Added precaution

DRAWING NO.	EDC-150825-91-21
PART NO.	FX8C-140P-SV(91)
CODE NO.	CL578-0507-5-91

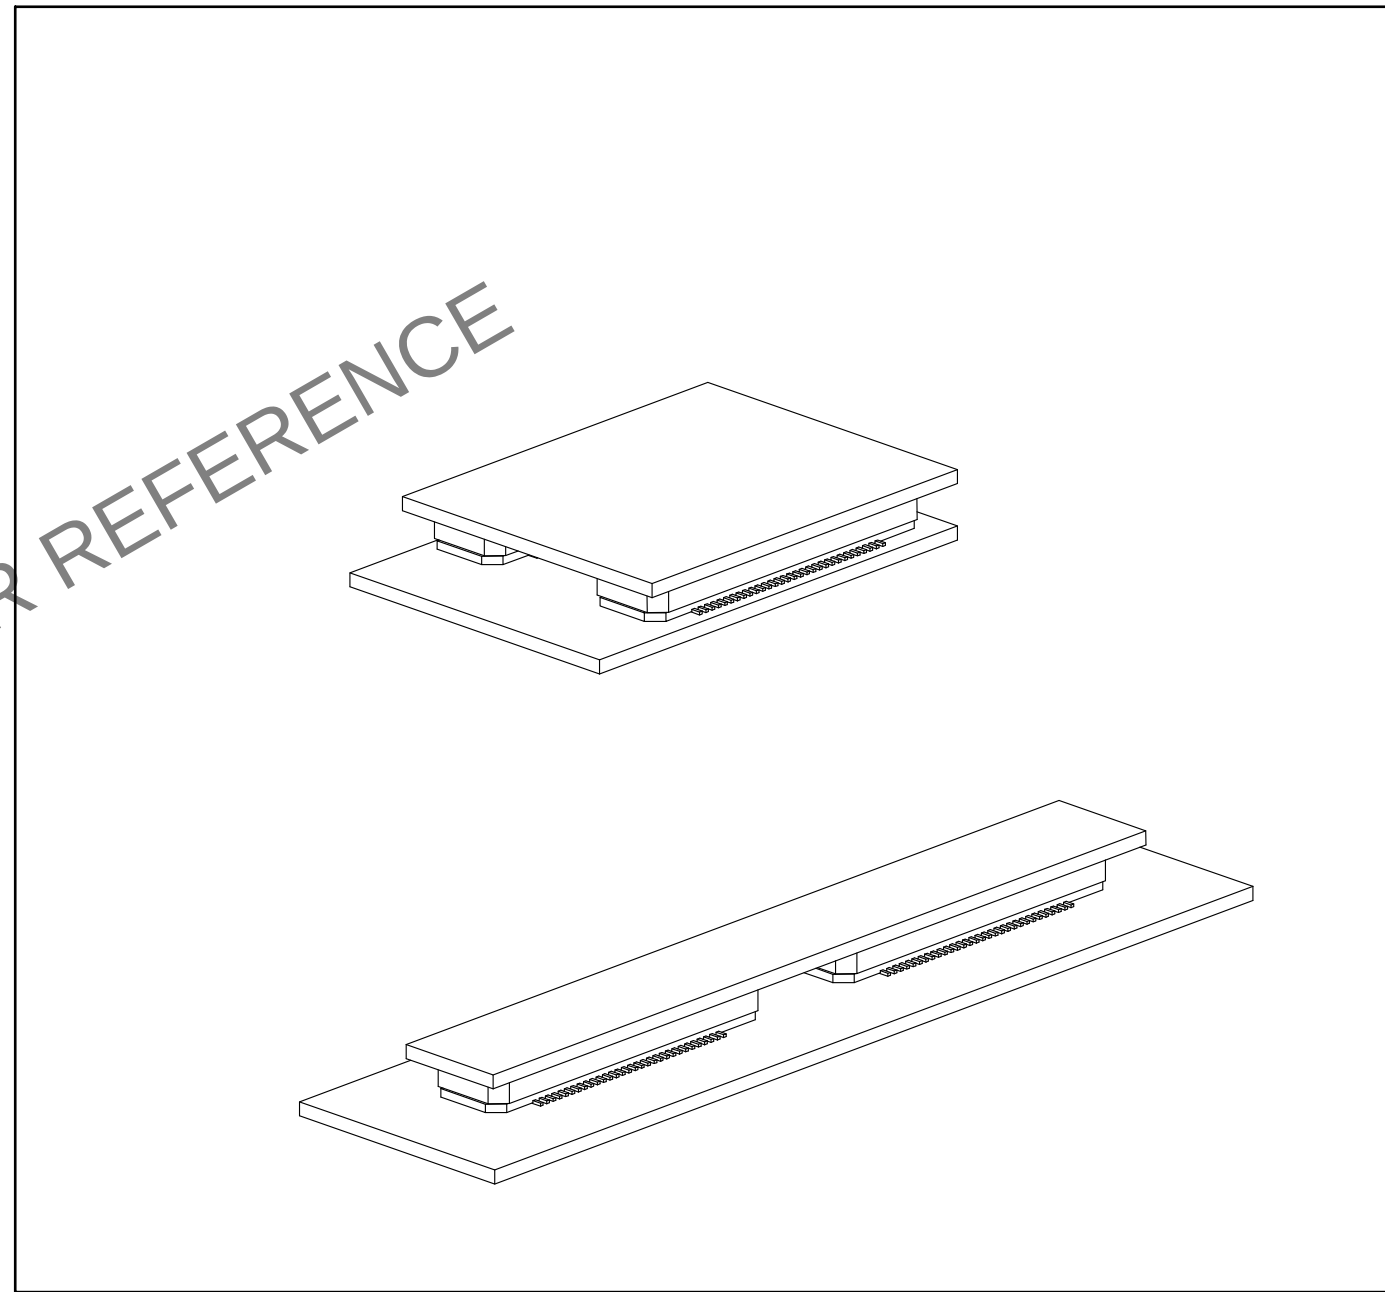
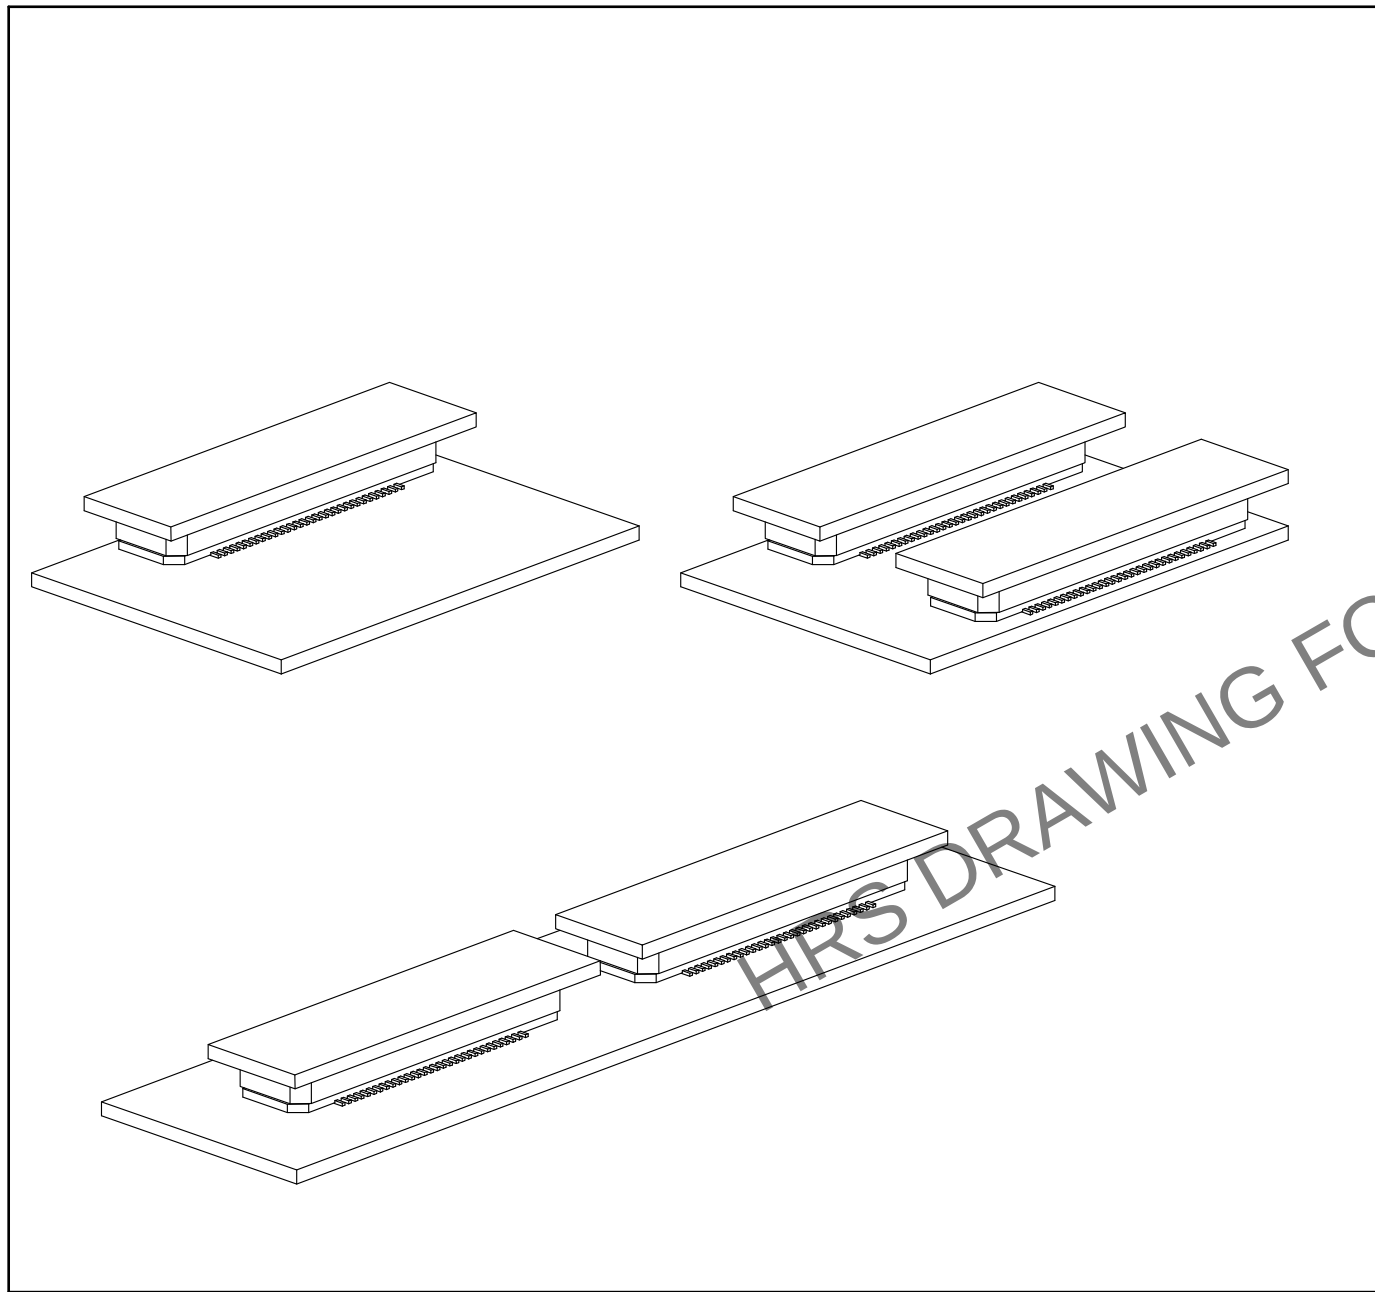
【Precaution】

When a board with multiple connectors mounted is mated, the connector may be damaged or deformed.
Please divide one side of the board so only one connector is mated per board.
